www.hchealth.orgFacebook: www.facebook.com/hocohealth**Maura J. Rossman, M.D., Health Officer**RECEIPT DATE: 4-2-21 **ONSITE SEWAGE DISPOSAL SYSTEM**P 508830APPROVAL DATE: 5/13/21 **PERMIT: CONSTRUCTION**

ONSITE SEWAGE DISPOSAL SYSTEM DESIGN PLAN
**LOT 14
LINDEN GROVE**
LIBER 19209, FOLIO 403
PLAT NO. 25069
ELECTION DISTRICT No. 4
HOWARD COUNTY, MARYLAND
ADDRESS: 1409 HERITAGE RIDGE ROAD
WOODBINE, MARYLAND 21797

From: Bricker, Robert <RBricker@howardcountymd.gov>
Sent: Monday, September 21, 2020 1:31 PM
To: Ryan Ketner
Cc: Michael Boyce
Subject: Linden Grove_Lot 14_OSDS Design Plan

TRENCH/DRAINFIELD DATA

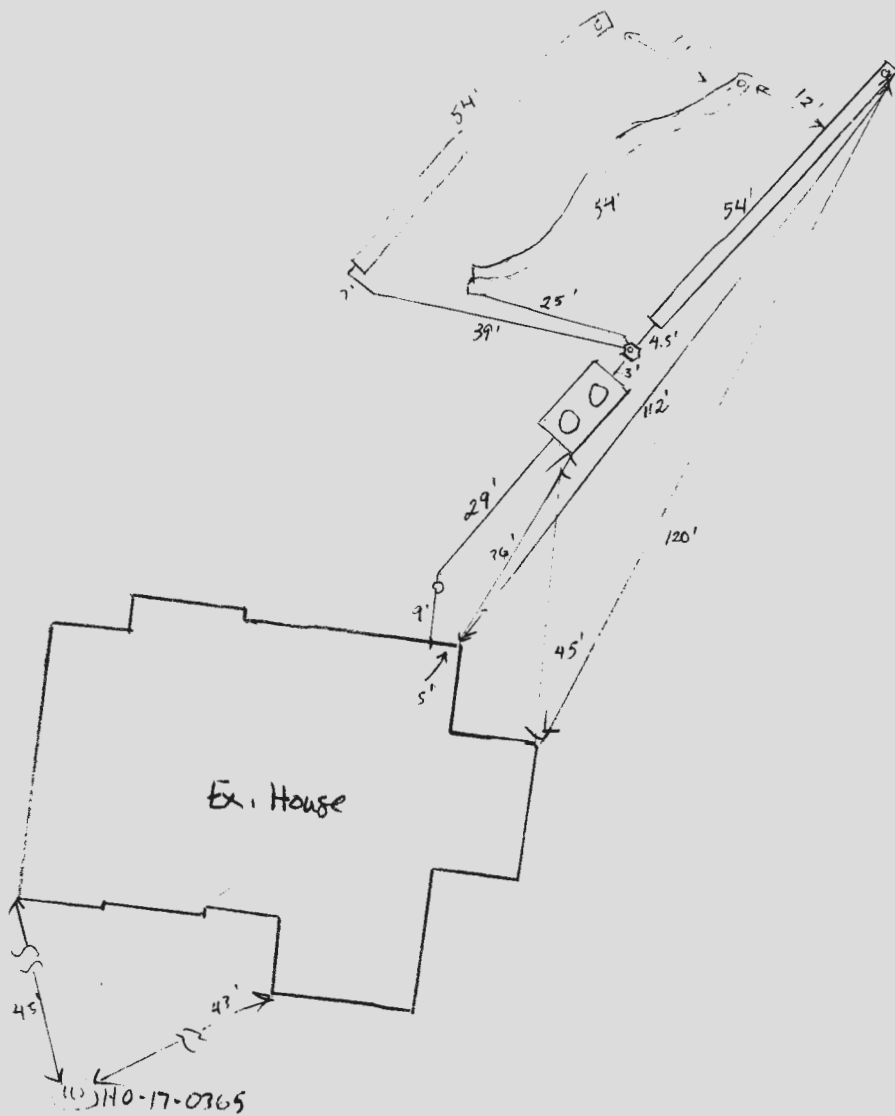
4/27/21 SDA not staked (ST) 5/4/21 3 x 52' trenches staked out on contour. SL confirmed to be coming out of house in expected location - yard has been graded down to level of basement floor, tank stake is 1' higher in elevation than basement floor as expected (S)

5/12/21 Tank set. SL constructed. Trenches constructed. D-box set + leveled. (Water leaking from one exit. Re-insp for d box water leak (S) 5/13/21 - d box repaired no leak detected, levels set. OK to backfill. (R))

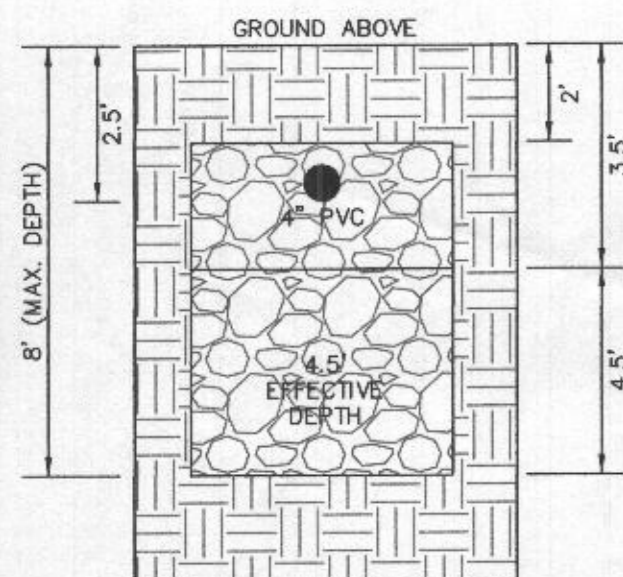
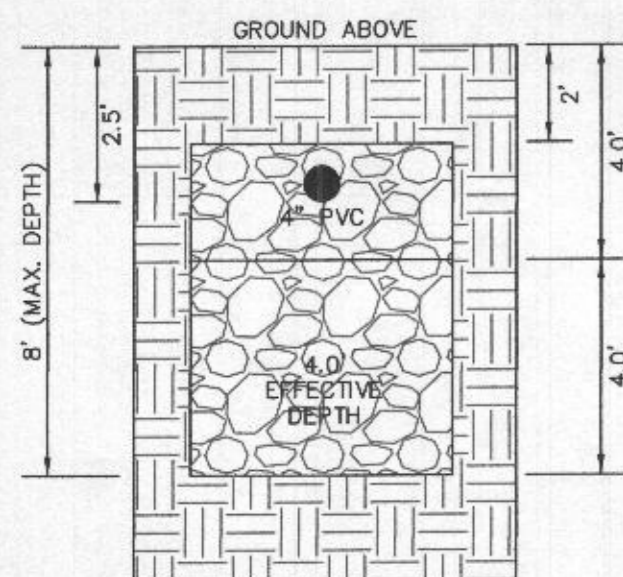
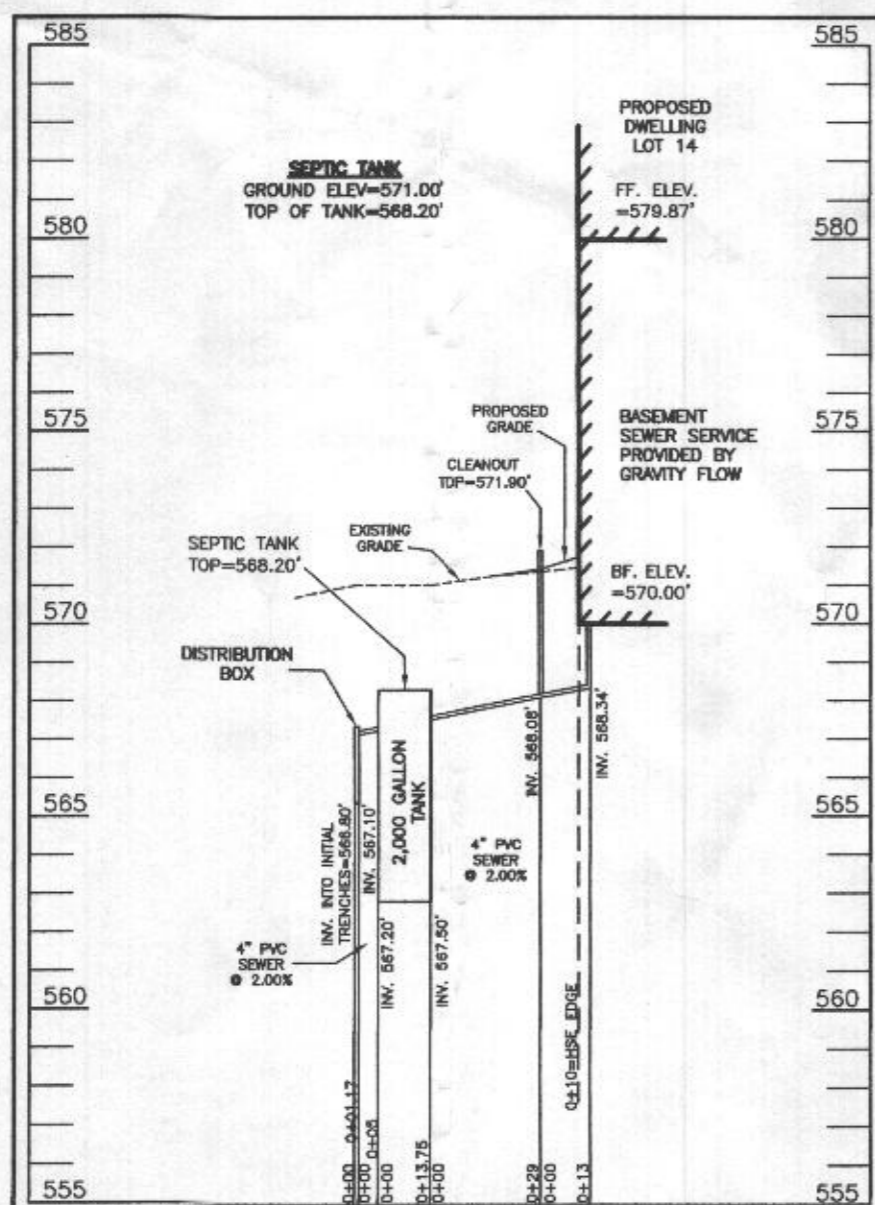
I have completed review of the OSDS Design Plan submitted for Linden Grove -Lot 14 (1409 Heritage Ridge Road). The plan cannot be approved at this time. The following issues are cited:

1. The calculated coefficients for reduction of trench length are incorrect for each of the three distribution systems. As a result, the calculated trench lengths for the respective systems are incorrect.
2. Efficient use of the SDA can be optimized by raising the sewer invert at the foundation by about 0.5 foot. This should allow you to plan a 57-ft trench from boundary to boundary across the upper SDA.
3. The spacing between trenches is more than the minimum required. I may or may not approve a plan with such an error, depending on the site characteristics. My purpose in bringing up the issue is that the mistake may be due to a mathematical error.

3. INITIAL TRENCH DESIGN (6 BDRM x 150 GPD/BDRM = 900 GPD)
900 GPD ÷ 0.8 APP. RATE = 1,125 SF
USE 3' WIDE TRENCH WITH 48" GRAVEL BELOW PIPE
11' MIN. SPACING BETWEEN TRENCH EDGES
1,125 SF ÷ 3' WIDTH = 375 LF x 0.42 (SIDEWALL REDUCTION) = 157.50 LF MIN.
USE 3 52.50' LONG TRENCHES = 157.50 LF

4. 1ST REPLACEMENT TRENCH DESIGN (6 BDRM x 150 GPD/BDRM = 900 GPD)
900 GPD ÷ 1.2 APP. RATE = 750 SF
USE 3' WIDE TRENCH WITH 60" GRAVEL BELOW PIPE
12' MIN. SPACING BETWEEN TRENCH EDGES
750 SF ÷ 3' WIDTH = 250 LF x 0.38 (SIDEWALL REDUCTION) = 95 LF MIN.
USE 2 47.50' LONG TRENCHES = 95 LF

5. 2ND REPLACEMENT TRENCH DESIGN (6 BDRM x 150 GPD/BDRM = 900 GPD)
900 GPD ÷ 0.8 APP. RATE = 1,125 SF
USE 3' WIDE TRENCH WITH 60" GRAVEL BELOW PIPE
11' MIN. SPACING BETWEEN TRENCH EDGES
1,125 SF ÷ 3' WIDTH = 375 LF x 0.42 (SIDEWALL REDUCTION) = 157.50 LF MIN.
USE 2 78.75' LONG TRENCH = 157.50 LF

PLEASE SEE THE CALCULATED SIDEWALL REDUCTION CALCULATION SHEET. I BELIEVE THIS IS CORRECT, PLEASE LET ME KNOW IF SOMETHING IS STILL WRONG.
